# **NRC Perspective on the Risk Significance of Potential Consequences from Igneous Activity**

**February 14, 2007**

**Office of Nuclear Material Safety and Safeguards**  
**Division of High-Level Waste Repository Safety**

## Highlight of Concerns with ACNW Draft White Paper

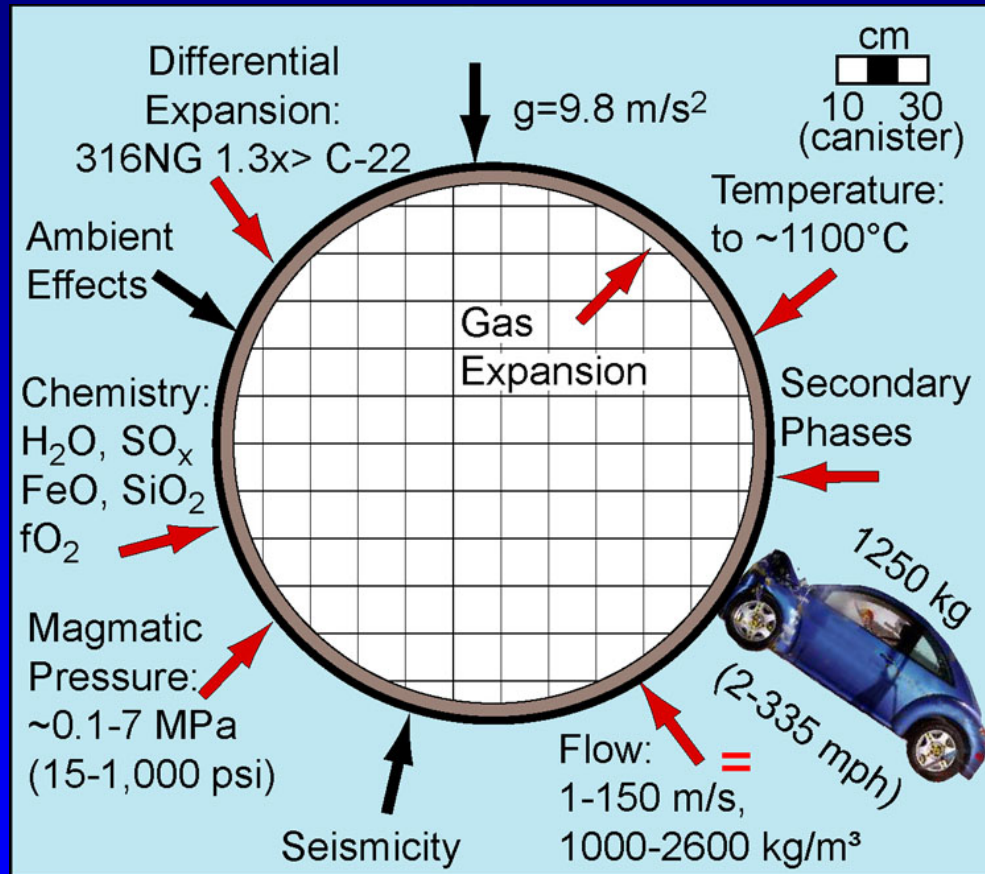
- ◆ **Draft white paper does not cite or discuss important NRC information on magma-drift interactions**
  - **Degassed magma flow**
  - **2-phase flow in dikes**
  - **Magma ascent**
- ◆ **Risk significance not provided for ACNW disagreements with NRC information**
- ◆ **Limitations in alternative models (e.g., observations that depressurized magmas flow  $>0.7$  km [0.4 mi] at surface) not addressed**

## Highlight of Concerns with ACNW Draft White Paper

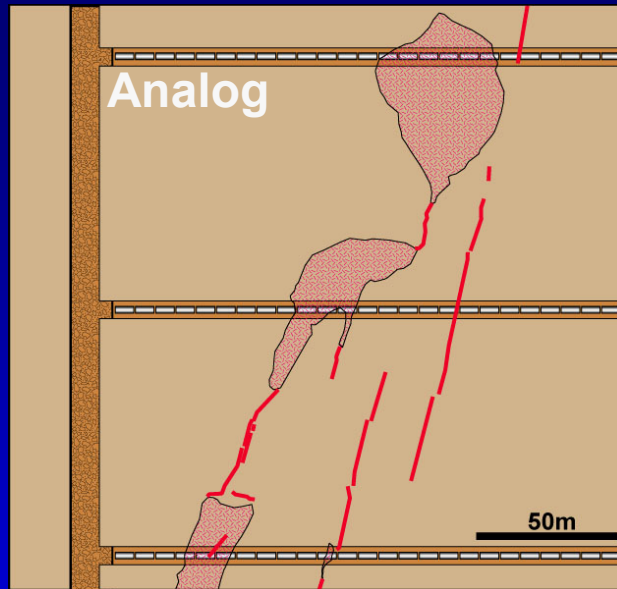
- ◆ **Draft white paper does not cite or discuss important NRC information on waste package response to magma conditions**
  - **Materials properties**
  - **Coupled igneous processes**

- ◆ **Risk significance not provided for ACNW disagreements with NRC information**

- ◆ **Limitations in alternative models (e.g., lack of coupling for thermal and mechanical effects) not addressed**

## Highlight of Concerns with ACNW Draft White Paper

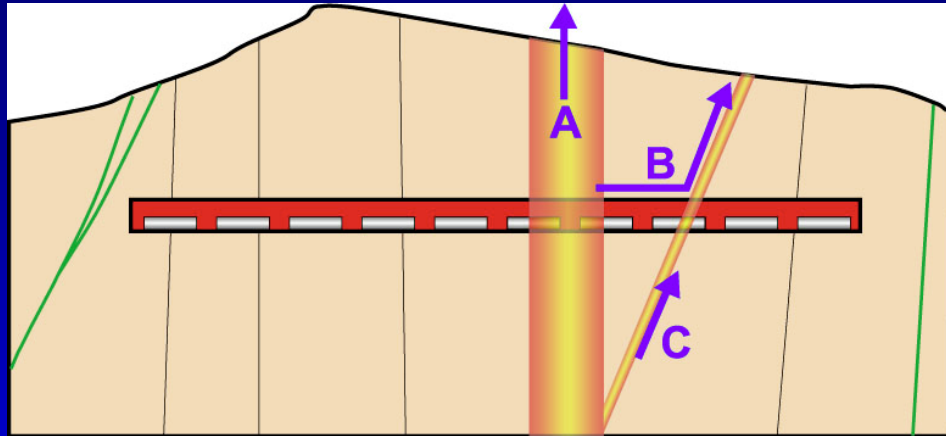
- ◆ **Draft white paper does not cite or discuss important NRC information on conduit development**
  - Magma ascent and flow
  - Field observations
- ◆ **Risk significance not provided for ACNW disagreements with NRC information**
- ◆ **Alternative information not addressed**

## Highlight of Concerns with ACNW Draft White Paper

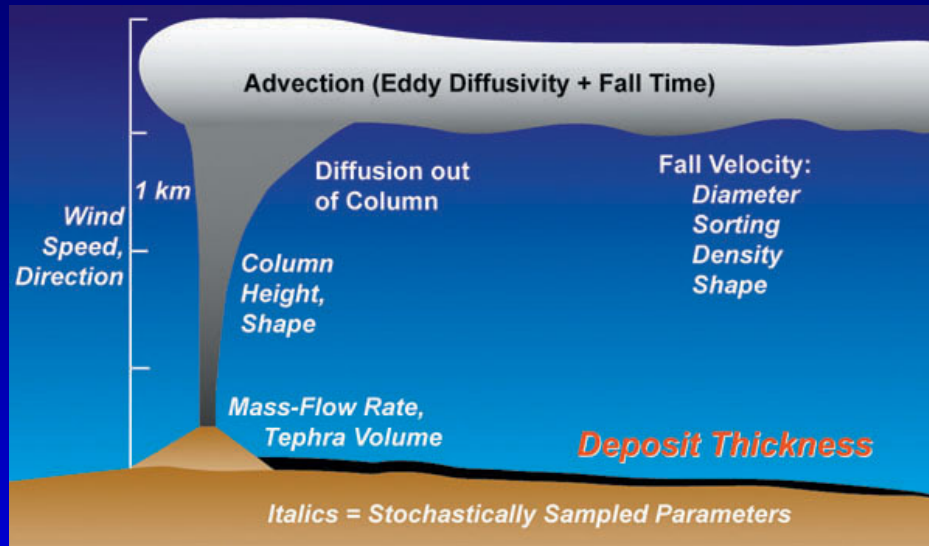
- ◆ **Draft white paper does not cite or discuss important NRC information on the formation of secondary breakouts**
  - Numerical and analog models
  - Field observations
- ◆ **Risk significance not provided for ACNW disagreements with NRC information**
- ◆ **Limitations in alternative models (e.g., lack of coupling between conduits and breakouts) not addressed**

## Highlight of Concerns with ACNW Draft White Paper

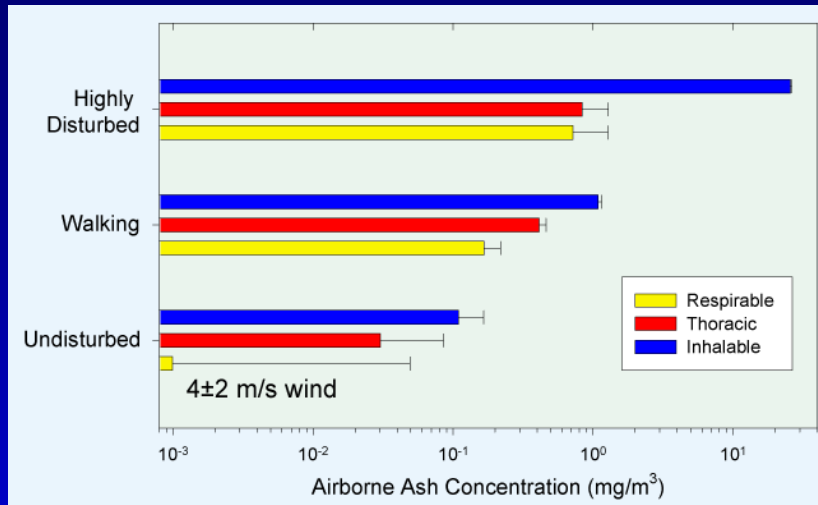
- ◆ **Draft white paper does not cite or discuss important NRC information on the airborne transport of radionuclides**
  - **Model support and sensitivity**
  - **Models for waste entrainment and eruption columns**
- ◆ **Risk significance not provided for ACNW disagreements with NRC information**
- ◆ **Limitations in alternative models (e.g., lack of model support for a gaussian plume) not addressed**

## Highlight of Concerns with ACNW Draft White Paper

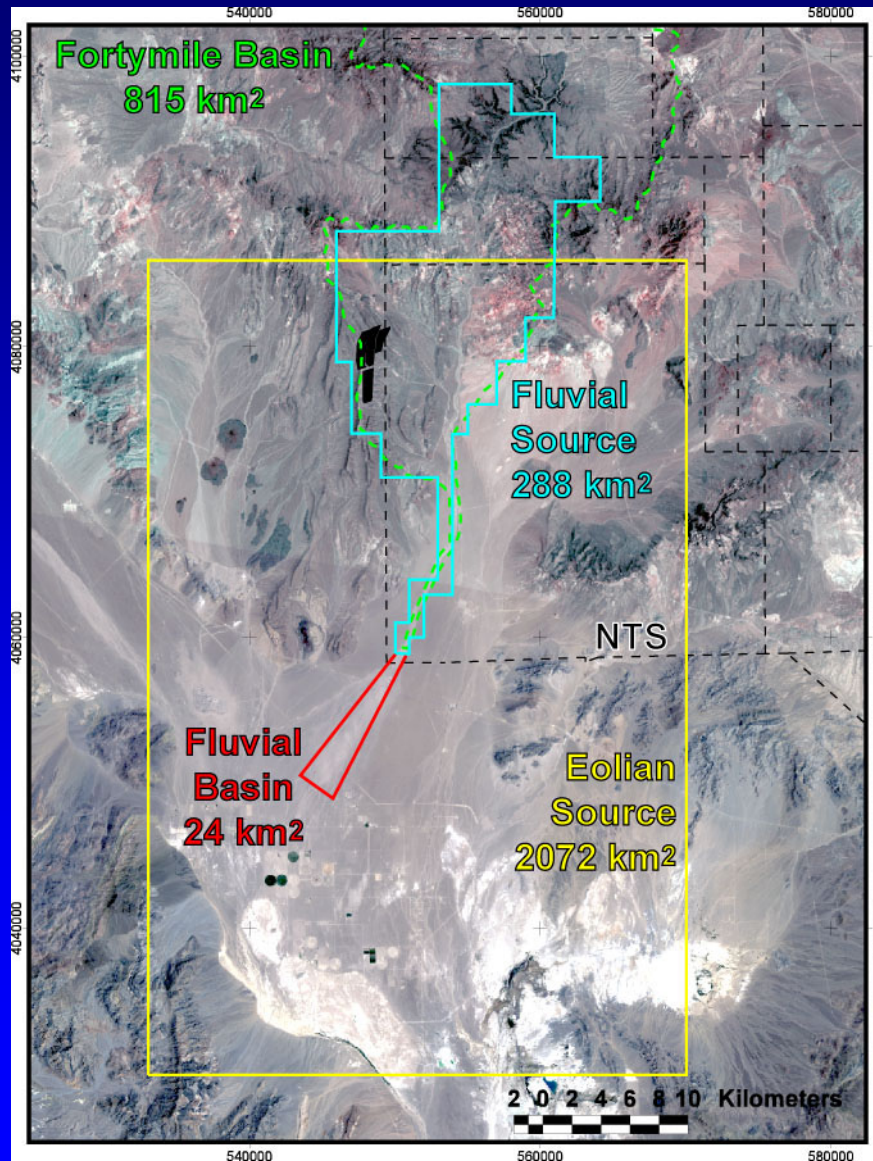
- ◆ **Draft white paper does not cite or discuss important NRC information on the tephra and waste particle-size distributions**
  - Analog data
  - Characteristics of Yucca Mountain region
- ◆ **Risk significance not provided for ACNW disagreements with NRC information**
- ◆ **Risk significance of alternative conceptual models or alternative size ranges not addressed**
